**LAND USE APPLICATION SUMMARY**

*Property Location:* 113 East 26<sup>th</sup> Street  
*Project Name:* 26<sup>th</sup> & Stevens Apartments  
*Prepared By:* Hilary Dvorak, Principal Planner, (612) 673-2639  
*Applicant:* CPM Development  
*Project Contact:* Scott Nelson with DJR Architecture  
*Request:* To construct a new mixed-use building with ground floor commercial space and 70 dwelling units.

<b>Conditional Use Permit</b>	To increase the height of the building.
<b>Variance</b>	To increase the maximum Floor Aare Ratio (FAR) of the building.
<b>Site Plan Review</b>	For a new mixed-use building with ground floor commercial space and 70 dwelling units.

D3 WEST EXTERIOR ELEVATION  
1/8" = 1'-0"

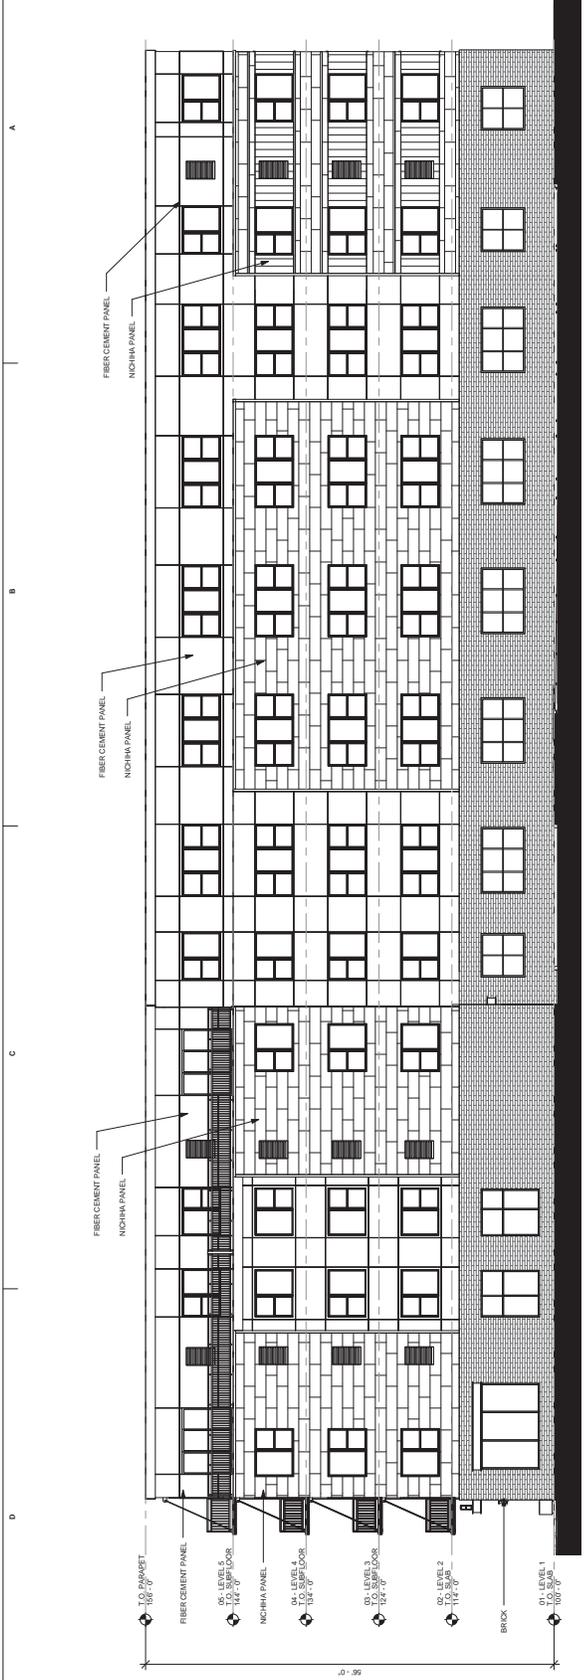
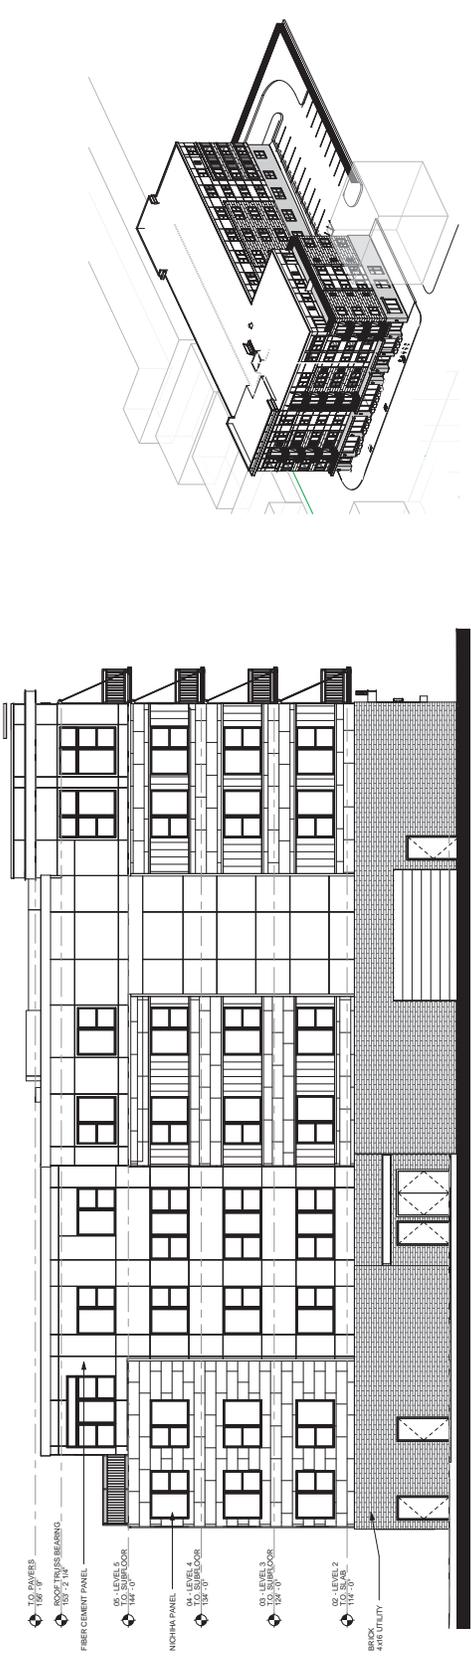
- The building is articulated with projecting balconies, varying materials and taller parapets on the northeast and southeast corners of the building.
- The site plan complies with crime prevention design elements as the building entrances are directly connected to the public sidewalk, there will be large windows on all sides of the building that maximize the opportunities for people to observe adjacent spaces and the public sidewalks and there will be lights located near all of the building entrances and in the surface parking lot.

- **Windows.** The development meets the minimum window percentages required by the zoning code except for the commercial portion of the building facing the parking lot as there are no windows. Adjacent to the commercial space on the interior side of the building is the outdoor area for the residents. In order to provide some privacy for the residents while utilizing this space CPED is recommending that the City Planning Commission grant alternative compliance to not require the full 30 percent windows along this wall. However, to help break up the brick wall CPED is recommending that a minimum of 10 percent windows be added to commercial portion of the building facing the parking lot.

1. Approval of the final site plan, landscaping plan, elevations and lighting plan by the Department of Community Planning and Economic Development.
2. All site improvements shall be completed by October 5, 2017, unless extended by the Zoning Administrator, or the permit may be revoked for non-compliance.
3. There shall be a minimum of six canopy trees provided on the site.
4. The landscape materials that are planted in the landscaped yards along the south and west property lines shall grow to a height of at least six feet.
5. A minimum of 10 percent windows shall be added to commercial portion of the building facing the parking lot.

RED LINE INDICATES PERMITTED  
BUILDING HEIGHT AT 56'-0"

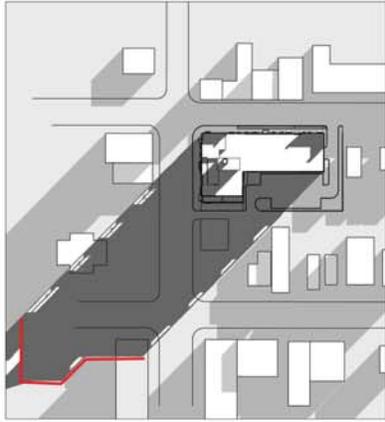
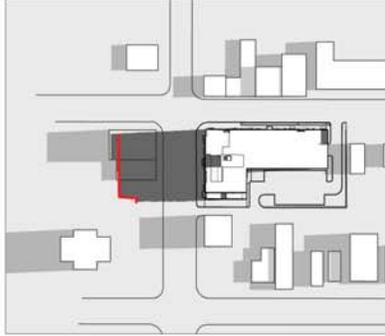
The height limitation in the C2 zoning district is four stories or 56 feet. The applicant is proposing to construct a building that is five stories or 61 feet. The majority of the building is 56 feet tall however; the parapet walls on the northeast and southeast corners of the building are five feet taller to provide architectural interest therefore making the overall height of the building 61 feet. The proposal to increase the height of the building from four stories or 56 feet to five stories or 61 feet will not be detrimental to or endanger the public health, safety, comfort or general welfare.

impede the normal or orderly development and improvement of surrounding property. The majority of the building is 56 feet tall however; the parapet walls on the northeast and southeast corners of the building are five feet taller to provide architectural interest. The building meets or exceeds all of the required setbacks in the C2 zoning district and the building has been designed in an “L” shape with the building mass pushed towards the property lines along the public streets.
